From: [REDACTED]
Sent: 25 April 2018 16:13
To: Planning
Cc: [REDACTED] Mr. Paul Bicknell; Cllr. Andy Cooper; Cllr. Dudley Wensley
Subject: A/38/18/RES Manor Nursery, Angmering

Please find attached Objection to planning application
A/38/18/RES Manor Nursery, Angmering.

Whilst accepting the principal of development on the Manor Nursery site, SAV strongly **OBJECTS** to elements of this application. Specifically, in respect of the proposed main access route to the development via the High Street. The issues highlighted below have already been noted in the previous application A/51/14/OUT for this site, but in our view, have been ignored by the developer.

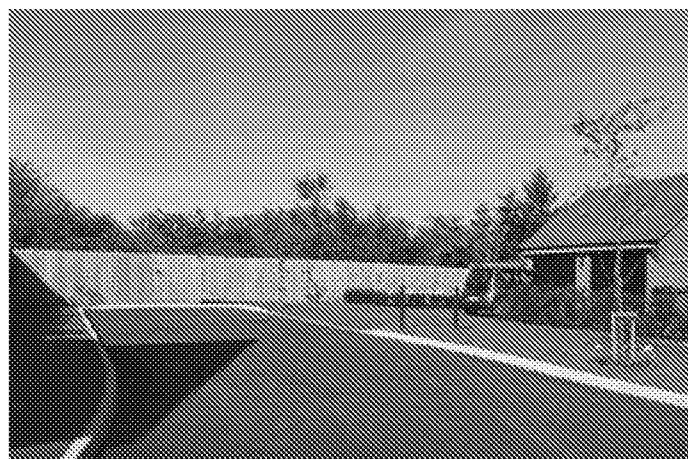
The proposed change to High Street clearly impacts upon the amenity value and safety of current users, urbanises the setting of the Conservation Area, and has

an unacceptable adverse impact on residents of adjoining listed buildings in that part of the High Street that have always had to rely on "on road" parking.

The introduction of footpaths between 1000mm and 1500mm wide are of specific concern relating to the safety of pedestrians and other types of non-motorised users when considering the current use of this rural lane.

Swanbourne Park - Approved Plans (A/82/12) showing "future" access road

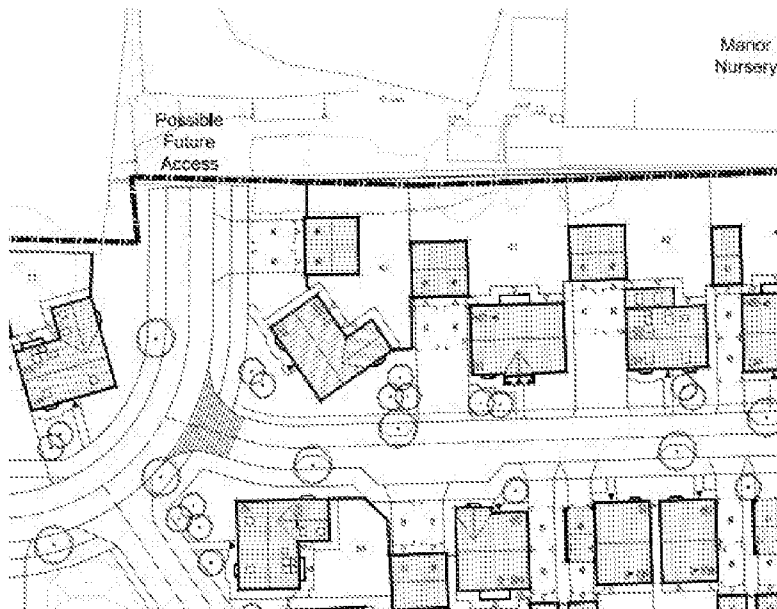
Original Proposed Main Access to the Site: The Roundstone Lane Strategic allocation was based on a Masterplan that was agreed by all the landowners and developers and on the strength of which planning permission was obtained. Each individual site was linked to each other via roads and footpaths.

A Visioning Brief was prepared by ADC which also indicated access to the site via the Swanbourne Park development. Whilst that Master Plan has been largely ignored, here there is an opportunity to utilise one aspect of its vision.

Nanson's Lane on the Swanbourne Park development is a much more suitable route. It is specifically designed as the main access route to the Manor Nursery site, without compromising the amenity role the High Street currently plays or the safety of its non-motorised users as access to the SDNP.

There's absolutely nothing stopping the developer linking the sites (Swanbourne Park and Manor Nursery) using the existing Nanson's Lane access with limited

modifications to the Manor Nursery site layout. Indeed, the applicant's site layout confirms that Nanson's Lane will be used as a non-motorised user access to Roundstone Lane via the Swanbourne Park development, however, at a cost to the existing users and residents of the High Street.
